APPLICATION NO.	FILING DATE	FIRST NAMED INVENTOR	ATTORNEY DOCKET NO.	CONFIRMATION NO.
10/518,490	12/20/2004	Erich Litwing	016906-0361	5493
22428 7590 08/08/2007 FOLEY AND LARDNER LLP SUITE 500 3000 K STREET NW WASHINGTON, DC 20007			EXAMINER CORRIGAN, JOSEPH JAMES	
			ART UNIT 3709	PAPER NUMBER
			MAIL DATE 08/08/2007	DELIVERY MODE PAPER

Office Action Summary	Application No.		Applicant(s)	
	10/518,490		LITWING ET AL.	
	Examiner		Art Unit	
	joseph corrigan		3709

DETAILED ACTION

FIG. 1

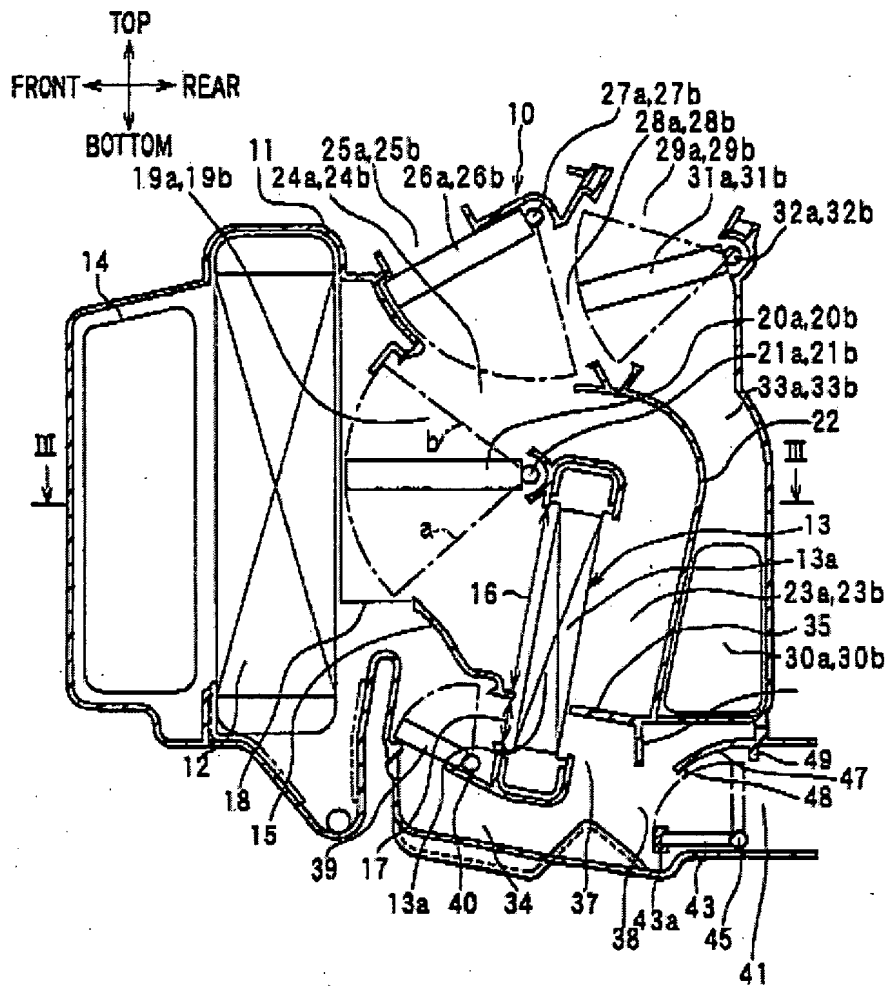
3. In re claim 1, Derleth et al '082 discloses a heating and/or air conditioning system for a motor vehicle, having a housing (10), the housing being composed of a plurality of housing segments (see figs. 1 and 5), characterized in that at least one housing segment is designed as an insert part (11, fig. 5), the insert part (11, fig. 5) being inserted into the remaining housing only after the remaining housing is installed in the motor vehicle, and the insert part (11, fig. 5) comprising at least one functional subassembly (43-45, fig. 5).

4. In re claim 2, Derleth et al '082 discloses invention above and further discloses that the functional subassembly (43-45, fig. 5) comprises at least one air-guiding means (41).

FIG. 5

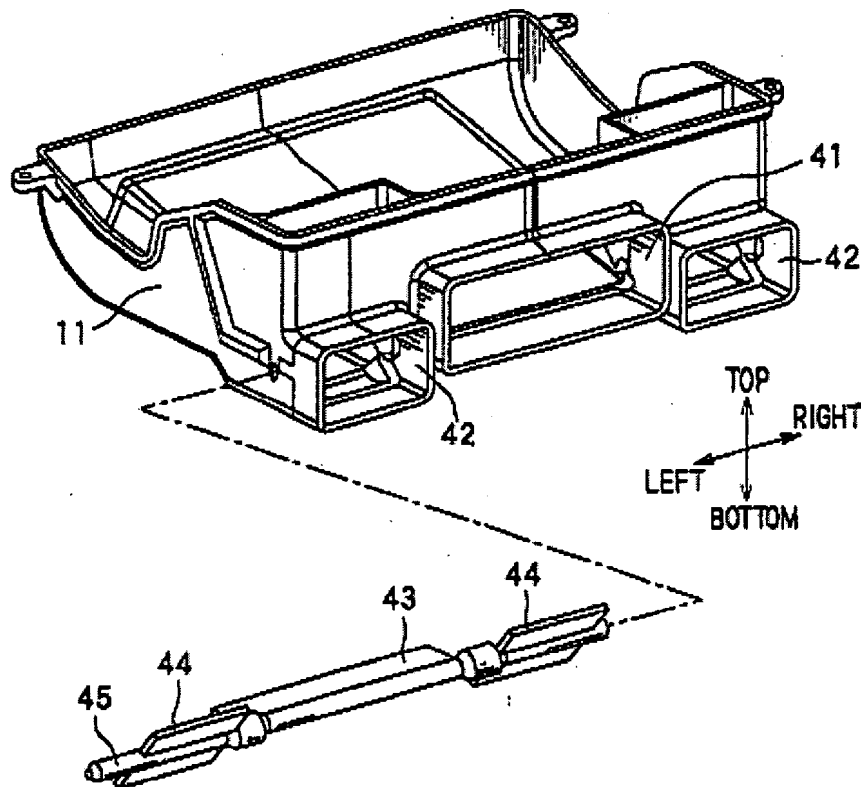
3. In re claim 3, Derleth et al '082 discloses invention above and further discloses that the functional subassembly is a mixing module (24) for a rear region.

4. In re claim 4, Derleth et al '082 discloses invention above and further discloses that the functional subassembly (43-45, fig. 5) comprises a hot air supply (13) and/or a cold air supply (12).

5. In re claim 5, Derleth et al '082 discloses invention above and further discloses that the functional subassembly (43-45, fig. 5) comprises at least one mixing flap (44).

6. In re claim 6, Derleth et al '082 discloses invention above and further discloses that the functional subassembly comprises at least one drive (**REFERENCE A**) for the at least one mixing flap (44).

7. In re claim 7, Derleth et al '082 discloses invention above and further discloses that the insert part (11, fig. 5) is formed symmetrically with respect to a longitudinal axis (L).
